# Access Compliance Report

## Public Rights-of-Way

### (Curb Ramps)

Intersection ID: 27339	Main Street: BALLANTYNE_MEDICAL_PL	Cross Street: CONLAN_CR	Location: NE
ADA ID: 13CE8C13294C	Ramp Type: Perp	Initial Pass/Fail: Fail	Overall Compliance: No
			Severity Score: 21.25

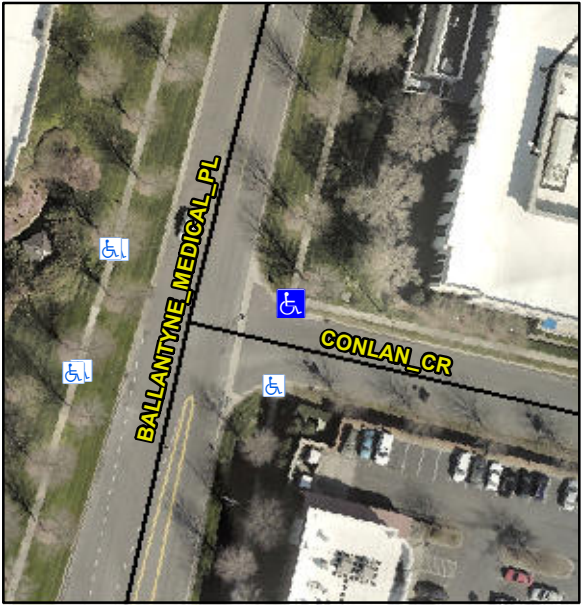
Codes/Mitigation Info/Possible Solution			Field Measurements/Component Compliance		
	Possible Solutions:		<b>Compliance</b>	<b>Description</b>	<b>Data</b>
	<b>Remove &amp; Replace Entire Ramp.</b>		<b>No</b>	Ramp Length (in)	<b>94.0</b>
			<b>No</b>	Ramp Width (in)	<b>39.0</b>
			<b>N/A</b>	Flare Type LT	<b>N/A</b>
			<b>N/A</b>	Flare Slope LT (%)	<b>N/A</b>
			<b>N/A</b>	Flare Traversable LT?	<b>N/A</b>
			<b>N/A</b>	Landing Length (in)	<b>N/A</b>
			<b>N/A</b>	Landing Width (in)	<b>N/A</b>
			<b>N/A</b>	Landing Slope (%)	<b>N/A</b>
			<b>N/A</b>	Landing X Slope (%)	<b>N/A</b>
<p>Surveyor Notes:</p> <p><b>N/A</b></p>			<b>N/A</b>	Landing Curb? (Y/N)	<b>N/A</b>
			<b>N/A</b>	Shared Landing?	<b>N/A</b>
			<b>N/A</b>	Gutter Ponding?	<b>N/A</b>
			<b>N/A</b>	Gutter Lip Ht (in)	<b>N/A</b>
			<b>N/A</b>	Painted X Walk1?	<b>No</b>
				X Walk 1 Direction	<b>To SW</b>
			<b>N/A</b>	X Walk 1 Width (in)	<b>N/A</b>
				X Walk 1 Slope (%)	<b>1.2</b>

X Walk 1 X Slope (%)	<b>1.3</b>
			<b>N/A</b>	Ramp inside XWalk1?	<b>N/A</b>
<p>PROW/ADA:</p> <p><b>R304.5.1, R304.2.2</b></p>			<b>N/A</b>	Road Slope (%)	<b>N/A</b>
			<b>N/A</b>	Road X Slope (%)	<b>N/A</b>
			<b>N/A</b>	Any Obstructions?	<b>N/A</b>
				Obstruction Type	
			<b>N/A</b>		
			<b>N/A</b>		
			<b>N/A</b>		
			<b>N/A</b>		
			<b>N/A</b>		
			<b>N/A</b>		
<p>Street 1 Name</p> <p>Stop Condition-Street 2</p> <p>Street 2 Name</p> <p>Stop Condition-Street 1</p>			<b>N/A</b>	Clear Space?	<b>N/A</b>
			<b>N/A</b>	Clear Space to XWalk (in)	<b>N/A</b>
			<b>N/A</b>	Storm Grate/Utility Hazard?	<b>N/A</b>
				Storm Grate/Utility Type	
			<b>N/A</b>		
			<b>N/A</b>		
			<b>N/A</b>		
			<b>N/A</b>		
			<b>N/A</b>		
			<b>N/A</b>		
<p>Total Cost:</p> <p><b>\$ 1850.00</b></p>			<b>Yes</b>	Surface Condition? (G/P)	<b>Good</b>
